ECE/TRANS/WP.29/2009/134
28 August 2009

World Forum for Harmonization of Vehicle Regulations

Amendments to the proposal for the 06 series of amendments to Regulation No. 83
(Emissions of M₁ and N₁ vehicles)

Submitted by the representative of the European Community */

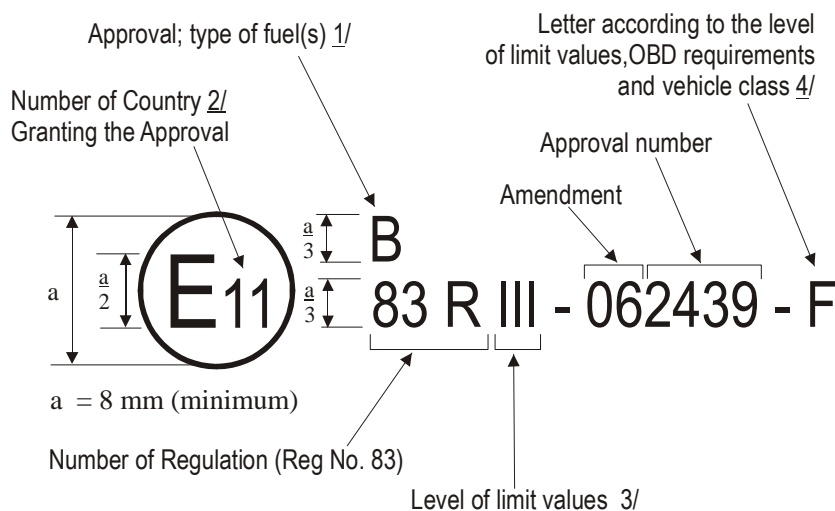
Replace the first figure of this annex, to read:

1/ B, C or D, according to type of fuel, paragraph 2.19. of this Regulation

2/ Number of Country according to footnote in paragraph 4.4.1. of this Regulation

3/ III denotes limit values corresponding to Table 1, paragraph 5.3.1.4. of this Regulation

4/ According to Table 1 of this Annex
